**CALIFORNIA COASTAL COMMISSION**

**STAFF REPORT: PERMIT AMENDMENT**

**APPLICATION NO.:** A5-RPV-93-005-A-19 (Ocean Trails/V.H. Property)

**SUMMARY OF AMENDMENT 19:**

A-5-RPV-93-005-A19 Exhibit 1 Applicant's Golf Course Habitat Program

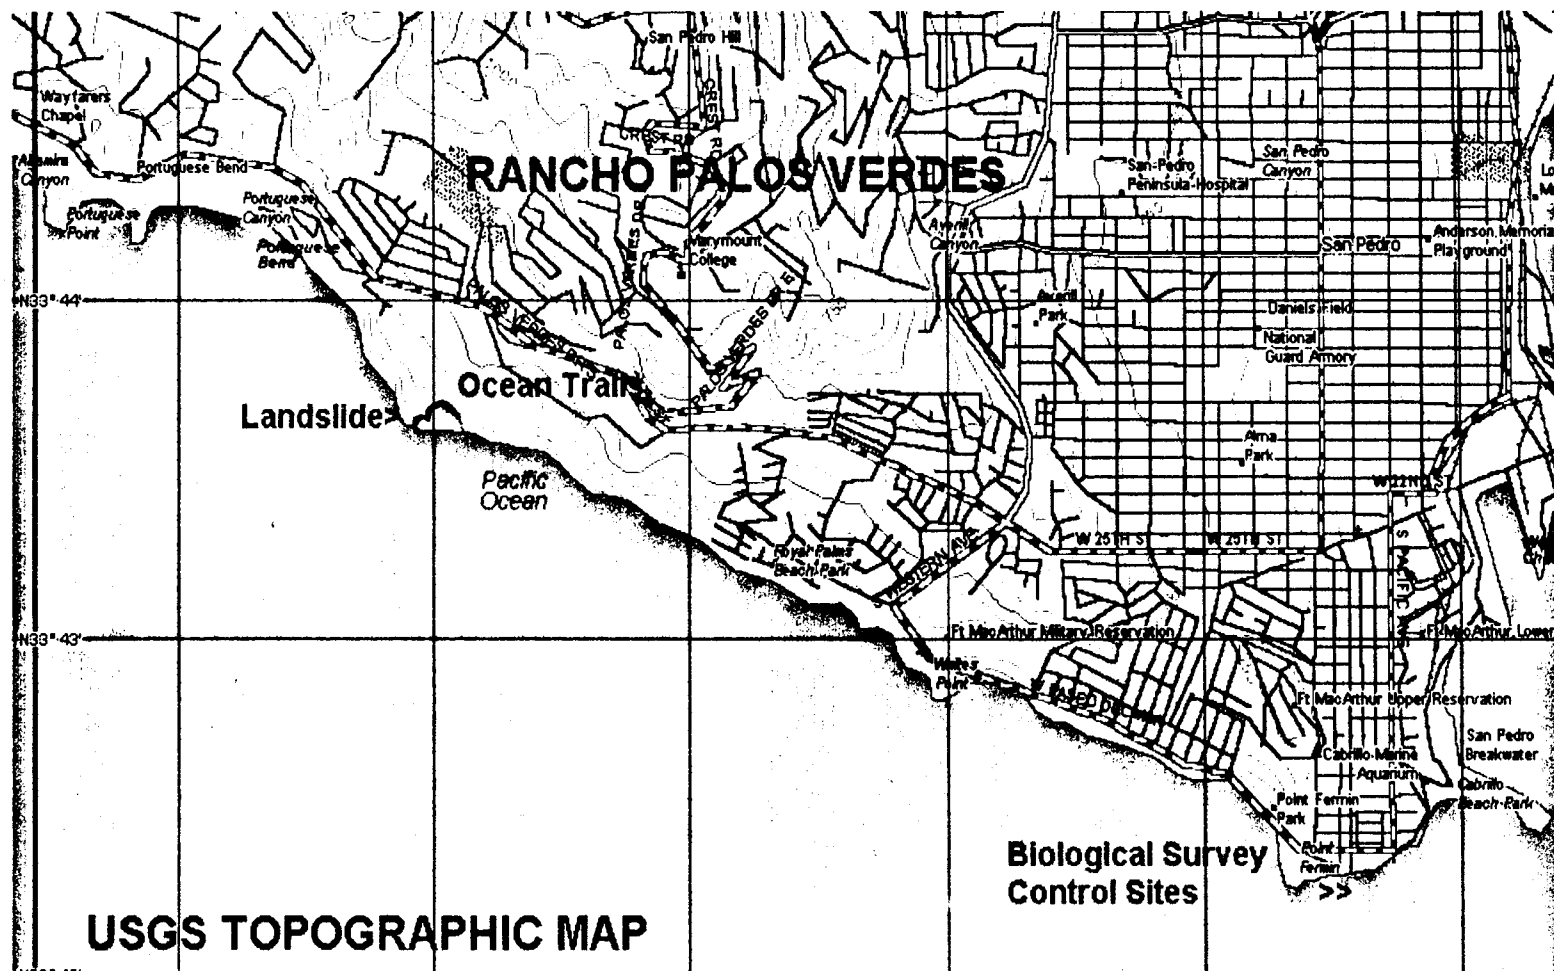
The applicant proposes to remove 0.8 acres of (CSS) is presently established on the golf course as part of Habitat Conservation Plan and coastal permit requirements and replant 1.14 acres of CSS in areas that are presently not planted in CSS. The applicant also proposes to reconfigure the location and configuration of the strips of coastal sage scrub habitat (CSS) installed within golf course boundaries. The result of the reconfiguration would be that the 0.7 of the CSS removed for golf course enhancements would be replaced on the golf course within the 1.14 acres of newly planted areas. The applicant also proposes to change the location of some of the CSS that the Commission already approved to be removed and replanted as part of the landslide repair. Additionally, 0.1 acres of CSS were to be removed in order to construct the tees and water features will be replaced in the same location it previously occupied. The applicant proposes to replant 1.2 acres removed by stockpiling, as previously approved, in its previous location. An area of restored golf course habitat, 0.3 acres in size that was damaged by stockpiling would be converted to golf course use. These 0.3 acres of CSS would be replaced within the 1.14 acres of newly planted CSS on the golf course.

The following is staff's summary of the habitat impacts and mitigations proposed of recent activities on the golf course. Staff concludes that the applicant needs to provide an additional 0.66 acres of CSS restoration to fully offset the impact of the proposed project and to be consistent with the certified LCP.

The applicant has prepared a map that summarizes golf removal and planting and landslide removal and replanting under this proposed amendment, the original permit and the landside repair amendment, A-5-RPV-93-005-A15. This map combines the changes proposed in the permit amendment application with the applicant's previous obligations (See Exhibit 1).

In the original permit, the applicant agreed to plant 20 acres of coastal sage scrub on the golf course, submitted a plan showing 22 acres, and planted all but .56 acres (21.44 acres.) The landslide and its repair damaged 1.5 acres of coastal sage scrub on the golf course (which should leave 19.94 acres in place, although the applicant reports on Exhibit 1 that there is actually less than that, 19.7 acres.) The applicant, in completion of its past obligation and carrying out its present one asserts it will plant a total of 3 acres of CSS in four types of areas on the golf course that are designated as CSS in this plan:

- Areas not presently designated CSS (1.14 acres),
- An area designated for CSS in 1997 but never planted (0.56 acres),
- Areas cleared during construction of water features (0.1 acres), and
- Areas removed by landslide and its reconstruction (1.2 acres).

The applicant's position is that instead of mitigating for removal, it simply has to meet the obligation in the HCP, which it states it will carry out by providing 22.41 acres of CSS on the golf course after replanting is complete. Staff was unable to reconcile these figures, and has asked the applicant to recalculate, and to resurvey the golf course to determine the exact amount of existing coastal sage scrub. (See proposed Special Condition 37). Previously, the HCP (which is adopted by reference in Special Condition 8 of the CDP)

- (a) **Prior to issuance of the amended permit A5-RPV-93-005-A19, the applicant shall submit final detailed planting plans for the golf course habitat areas for the review and approval of the Executive Director. The applicant shall also agree in writing, in a form and content subject to the review and approval of the Executive Director, to maintain no fewer than 22.64 acres of coastal sage scrub on the golf course consistent with that plan. In addition the applicant shall identify, for the review and approval of the Executive Director, a location on or adjacent to the project site where it can plant no less than 0.66 acres additional coastal sage scrub mitigation. The golf course habitat shall be in locations generally consistent with the June 27, 2003 Plans by Dudek Associates. The final plan shall also include a maintenance schedule.**

**From:** Martie Clemons  
**Sent:** Wednesday, November 19, 2003 10:38 AM  
**To:** Mike Sweesy  
**Subject:** Hole 9 again

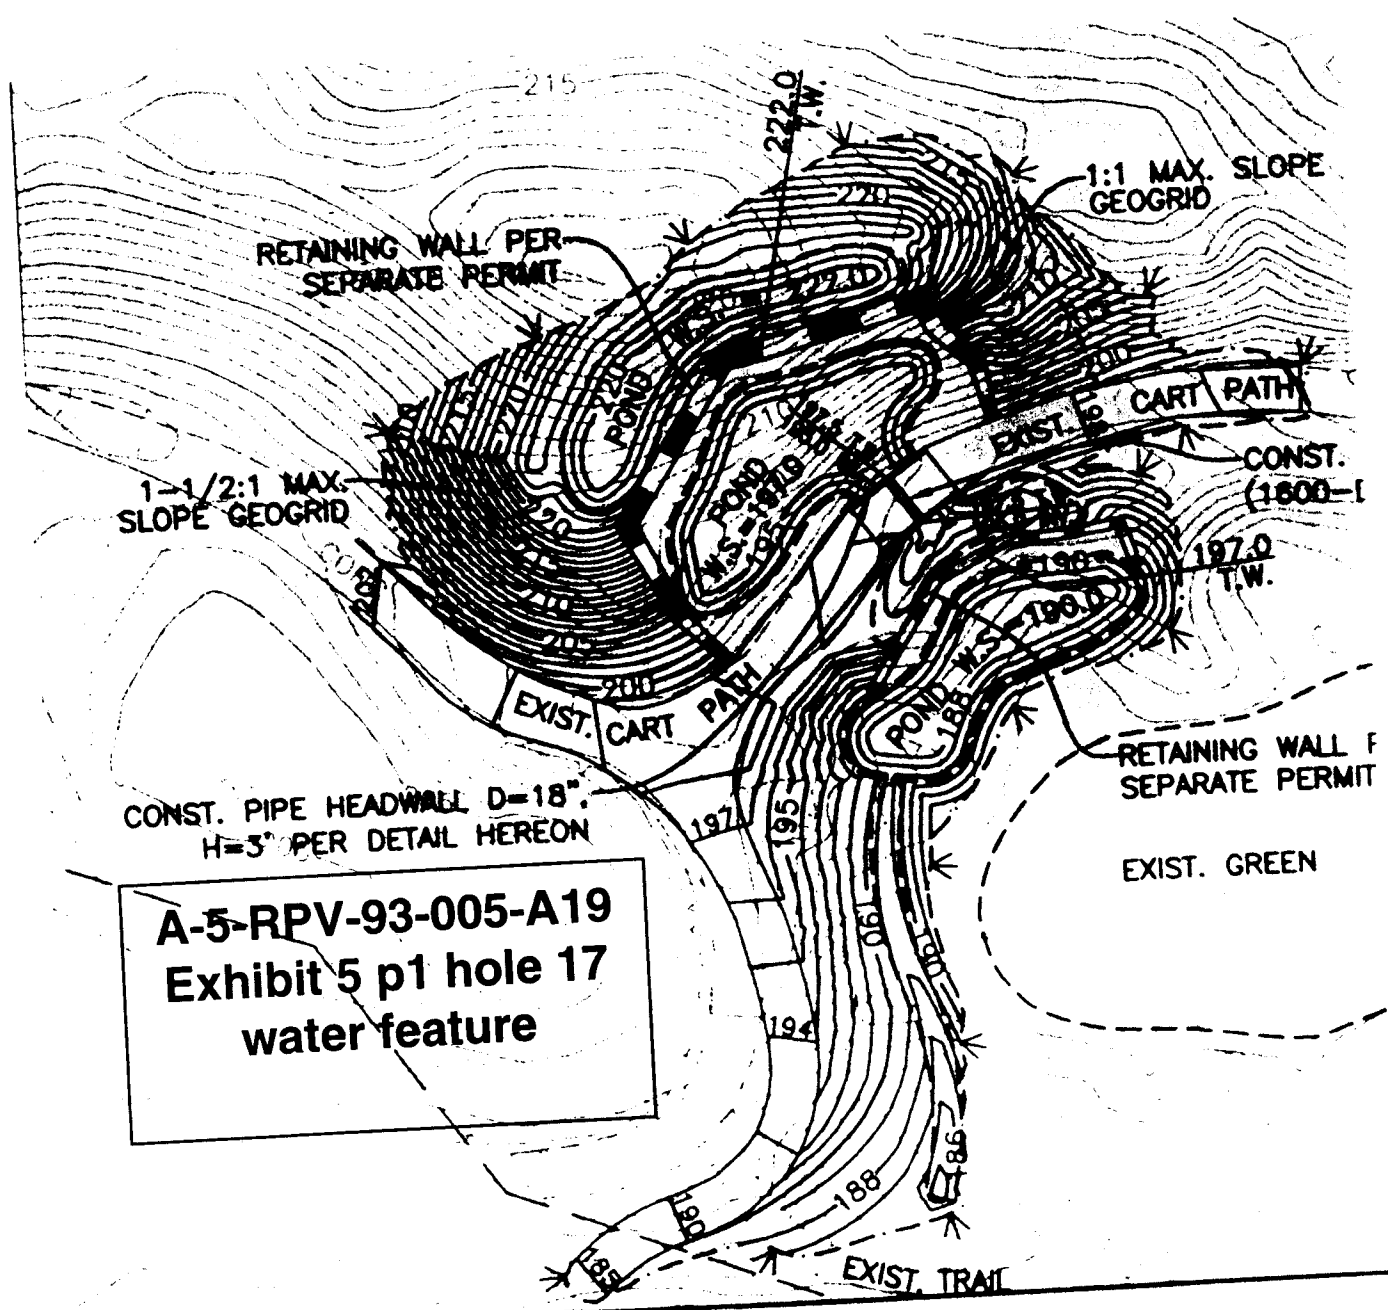
The proposed new tee at Hole 9 will remove 102 acres of freshwater marsh habitat proposed by the applicant in mitigation of some fill permitted in a coastal canyon (Exhibit 3). The applicant states that it has restored ample riparian vegetation elsewhere on the

site (see special condition 8.D.6) and that the area removed can be absorbed in the other restoration areas. This issue need not be evaluated because the new tee on Hole 9 is not recommended for approval. Since the applicant did not provide information in its original application to support the removal, there is no evidence supporting the removal of this habitat or which would enable the Commission to judge its conformance with either the requirements of the Bolsa Chica decision, or with the LCP standards cited below.

With the exception of the tees at Holes 3, 5 and 9, while the new tees are close to several trails, they are not closer to the trails than the existing tees. Hole 9 is extraordinarily close to a trail (Exhibit 3). It will also impact an area that was approved to be a wetland mitigation area and that has already been planted. Special conditions 29 and 32 that refer to replacing the trails after bluff failure provide that the applicant must relocate golf facilities if they prove to be a safety hazard to visitors rather than constructing net or fencing barriers on the course. In order to avoid this conflict, the Commission requires that the applicant eliminate this tee. The Commission does not require the tee on Hole 5 to be eliminated, but instead, in new special condition 38 restricts the new tee in Hole 5 to tournament use and may be used only during the six special events allowed on the golf course each year. With these restrictions and changes to assure that public access is protected, the Commission finds that the amended permit is consistent with the public access policies of the Coastal Act and of the certified LCP.

Pursuant to this concern, prior to issuance of the amended permit A-5-RPV-93 005-A19; the applicant shall submit revised plans for the review and approval of the Executive Director, eliminating the new tee at Hole 9. The applicant shall also acknowledge in writing that the new tee in Hole 5 is restricted to tournament use and may only be used during the six special events allowed on the golf course each year.

**A-5-RPV-93-005-A19**  
**Exhibit 5 p1 hole 17**  
**water feature**

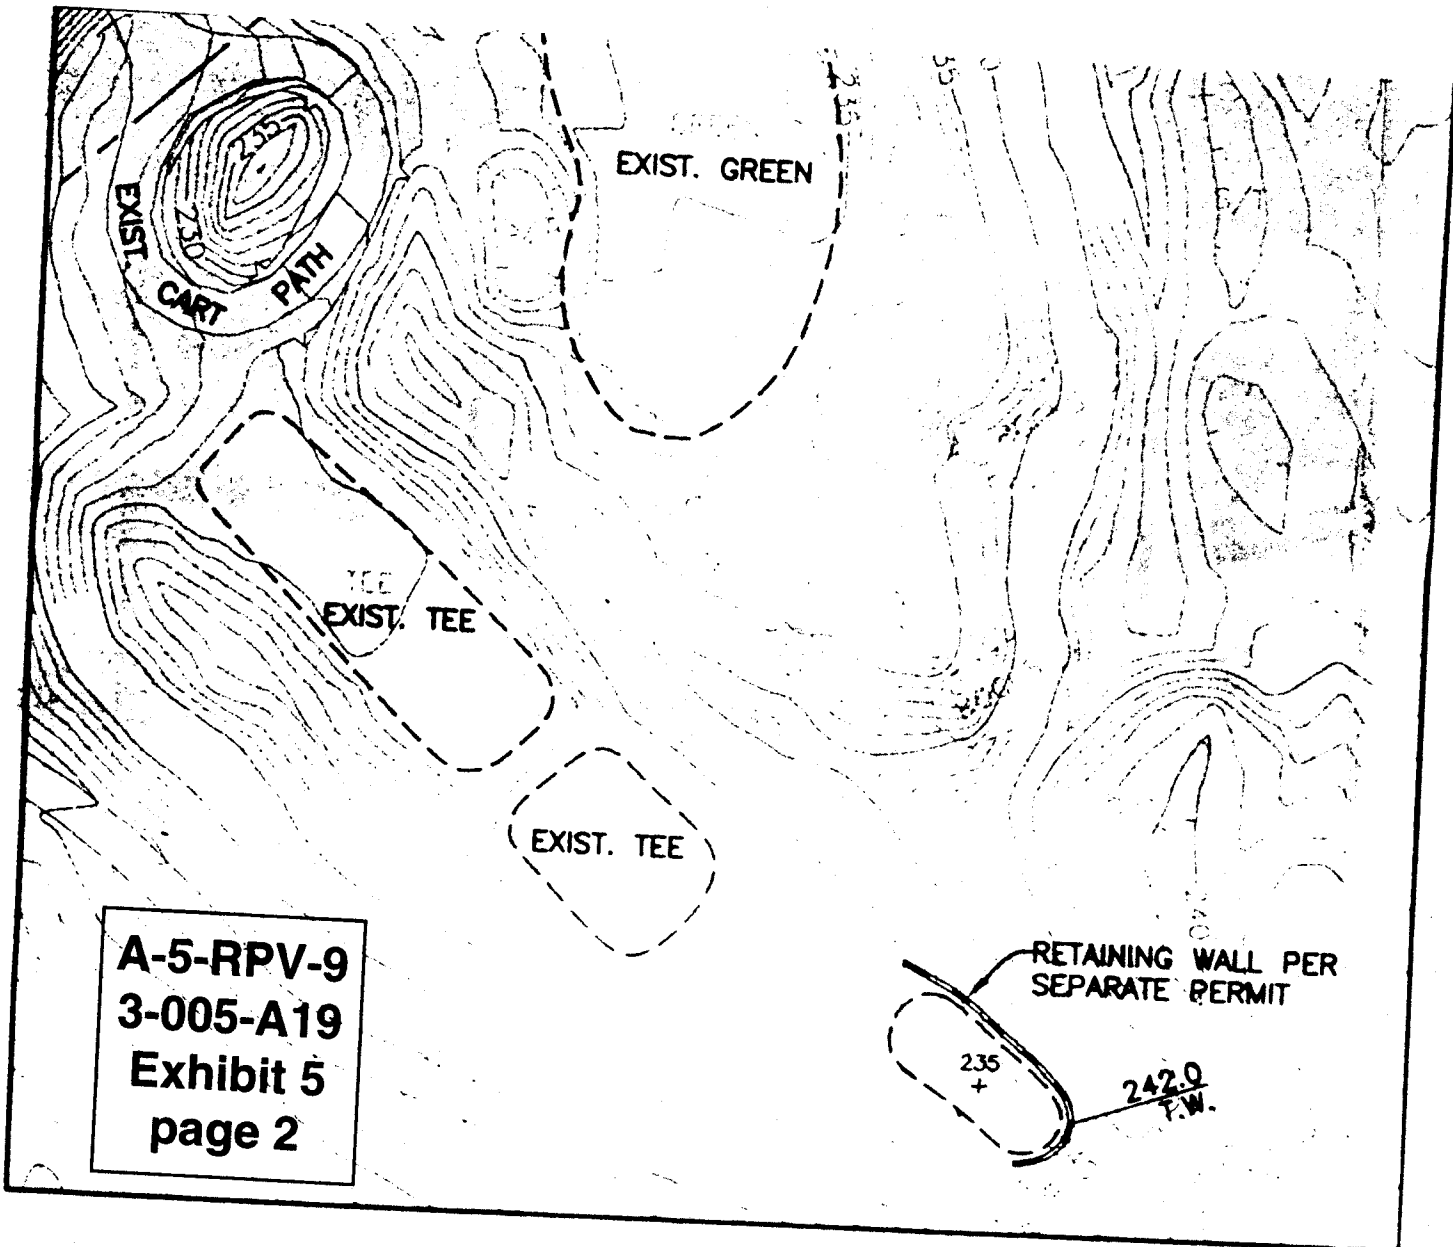
First, the applicant proposes to add three water features to the golf course, while acknowledging that the introduction of moisture into the bentonite sediments that underlay the site was instrumental in causing the failure of Slide "C". Second, by extending the golf holes by adding additional tees, the applicant will expand the area that is planted with turf, requiring irrigation, including water pipes and the like. In addition, several retaining walls with imitation rocks will be necessary to support the "waterfalls" which will cascade over the faces. Some retaining walls are planned in locations where the developer buried excess rock during construction of the golf course.

The applicant proposes these water features along with the safeguards recommended by the City and by its own consultant. These safeguards include a system of (clay) liners, monitoring wells and automatic cutoff valves so that leaks will not result in the infusion of water into the sediments of the site. The City requires the applicant to employ an independent lake consultant answerable to the City during installation of the water features. Nevertheless, the Commission is requiring that such devices be incorporated into the plans and then, that any change in lake design or in these mitigation measures be reported to the Executive Director to determine whether an amendment is necessary. For this reason, the applicant is required to provide working drawings and updated geologic reports to the Executive Director.

Prior to issuance of the amended permit A5-RPV-93-005-A19 the applicant shall provide for the review and approval of the Executive Director the following information concerning the artificial rock proposed for the water features:

The information shall be adequate to demonstrate to the satisfaction of the Executive Director that the artificial rocks and the materials used to construct them and/or attach them to the retaining walls will not be hazardous to marine life, plant or animal life or to the health of humans who may come into contact with the project lakes, streams or runoff.

A-5-RPV-93-005-A19  
Exhibit 5 p3  
Hole 1 Water Feature

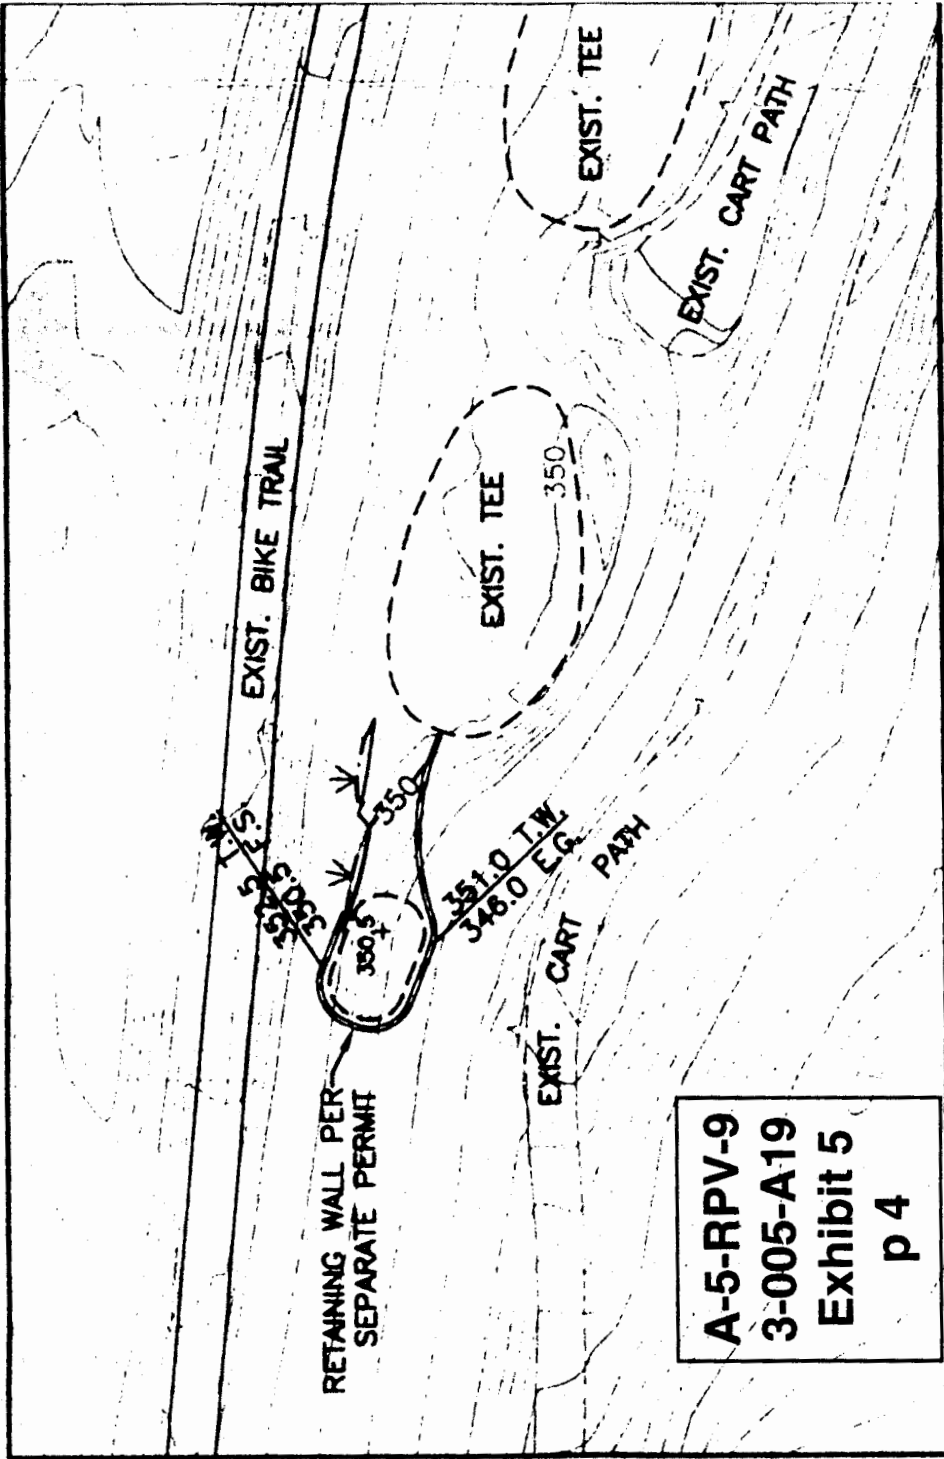
The applicant proposes water features at Holes 1, 4, and 17 and to relocate the fairway of Hole 1 within the golf course. In addition, the applicant proposes new tees at holes 2, 3, 4, 5, 7, 9 and 16. The applicant also requests an after-the-fact approval to create new back tees for Holes 1 and 12 within the slide repair areas, where grading is underway for slide repair. The back tee at Hole 1 will be elevated on fill and require a retaining wall. The new tee at Hole 12 requires a change in the location of the golf course habitat area. The changes at Holes 1, 4, 3, 5, and 12 require either removal of habitat or changes to the location of restoration pledged to mitigate landslide damage occurring as part of the landslide and its repair. The new tees at holes 1 and 12 are rough-graded. The changes in Hole 9 will impact about 102 square feet of wetland mitigation. The changes at Holes 4 and 5 require lot line adjustments. The lot line adjustments will have no effect on habitat; the change at Hole 5 will result in a drive across a vertical access trail that connects a five-car parking lot with the bluff edge trails (Exhibit 4).

**Hole #1:** Safety problems have been encountered on Hole #1. The configuration of the Hole in relation to Ocean Trails Drive causes golfers to hit their shots into automobile traffic. The proposed remedy to this situation is to realign the fairway and green eastward, away from Ocean Trails Drive (*Figure 1*).
